PUBLIC INTEREST REVIEW FOR GROUND WATER APPLICATIONS

TO: Water Rights Section Date April 1, 2004
 FROM: Ground Water/Hydrology Section Ivan Gall Reviewer's Name
 SUBJECT: Application G- 16190 Supersedes review of na Date of Review(s)

A. GENERAL INFORMATION: Applicant's Name: Leslie Rushing County: Jackson

A1. Applicant(s) seek(s) 0.022 cfs from one well(s) in the Rogue Basin,
Sterling Creek subbasin Quad Map: Sterling Creek

G-16190

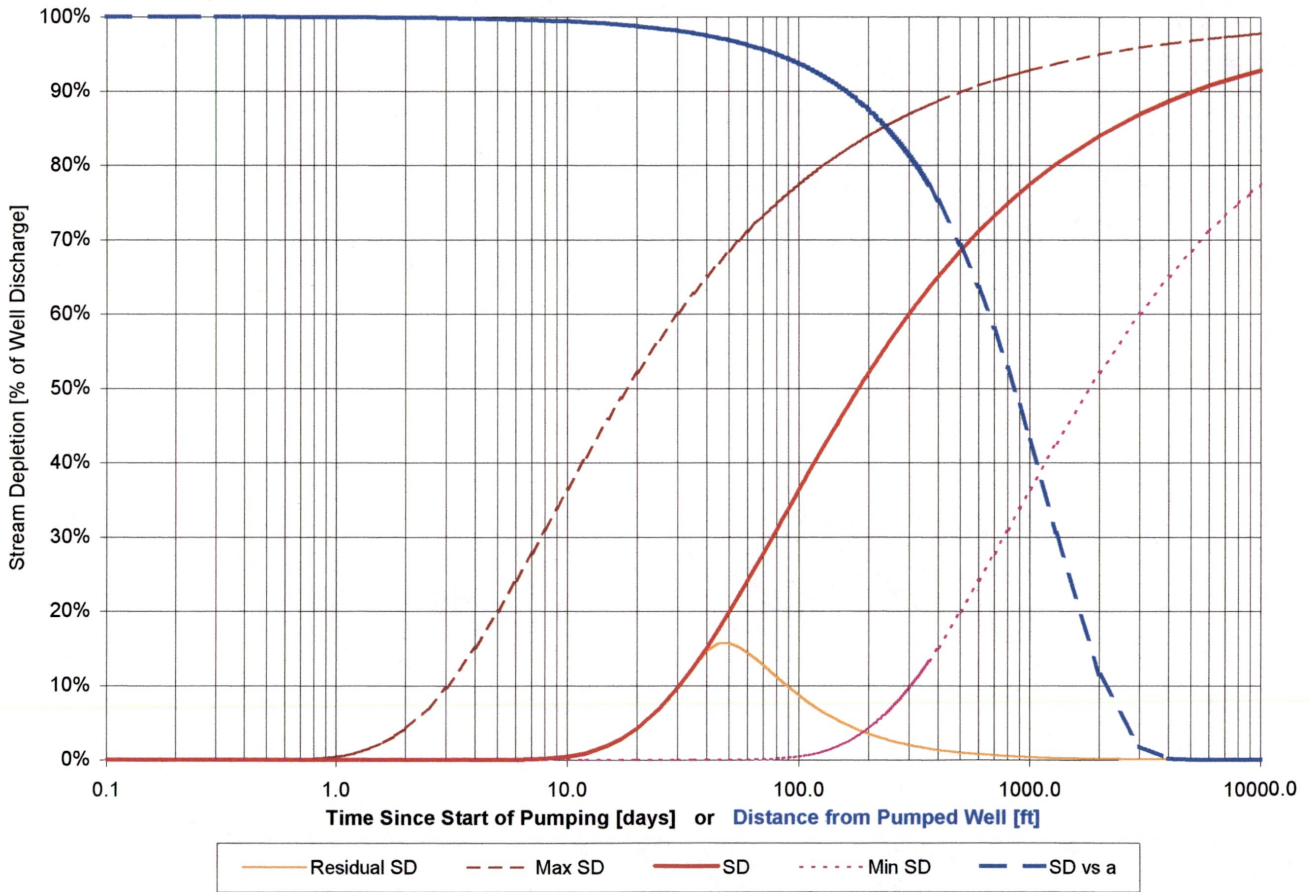
Basis for impact evaluation: Used Jenkins model; simple analytical model with values estimated from textbook for hydraulic conductivity and storage. Streambed conductance likely greater than that of aquifer, given steep nature of drainages. Stream width minimal.

C6. **SW / GW Remarks and Conditions It is very likely that the applicant's groundwater is hydraulically connected to nearby surface water. However, the hydraulic properties of the aquifer suggest that impact to local streamflow will be minimal. Simple analytical modeling using estimated values of aquifer hydraulic conductivity (K) and storage (S) indicate 10% or less of the pumping rate will be seen at a 2,100 feet distance. Existing water rights on the small streams, and personal observations by watermaster Bruce Sund, indicate that many of the small tributaries in this area have flow into the summer months, a function of groundwater discharging to maintain baseflow in the streams.**
